TO: DEVELOPMENT REVIEW BOARD DATE: 1/20/2000  
FROM: PROJECT COORDINATION  
SUBJECT: CASE 118-DR-99

REQUEST: Approve Site Plan & Elevations for a Retail Center  
PROJECT NAME: The Summit @ Scottsdale  
LOCATION: NEC Ashler Hills Drive & Scottsdale Road

STAFF RECOMMENDATION: APPROVE subject to the attached stipulations.

BUILDING 6, 7 & 8 - WEST ELEVATION  
1/2" = 1'-0"

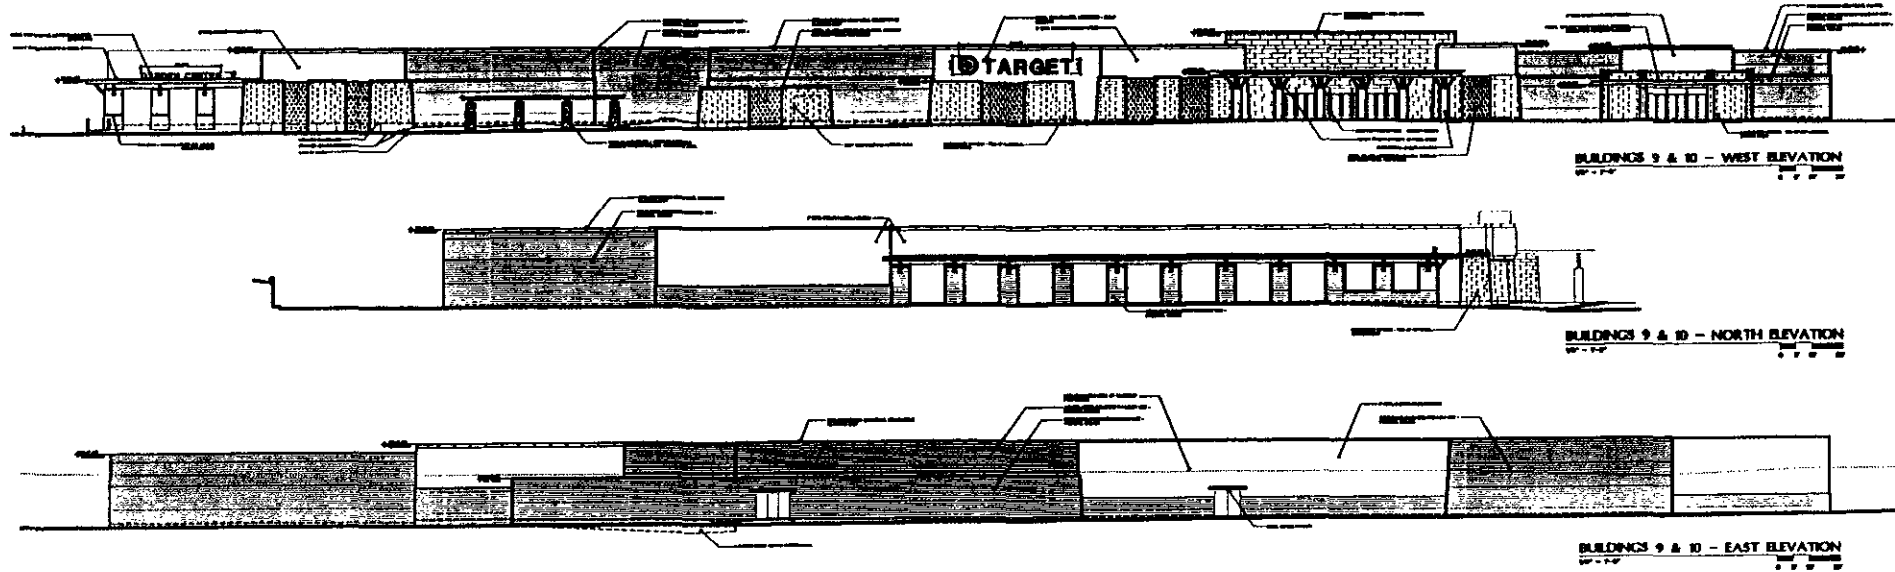
2. *The developer shall revise the proposed **REAR** elevations for the ~~"Target" building~~ building number ~~9~~ **1, 4, 6, 7, AND 11** through additional variation in the roofline. The revised building elevations shall be subject to Development Review Board study session approval, prior to the final plans submittal.*
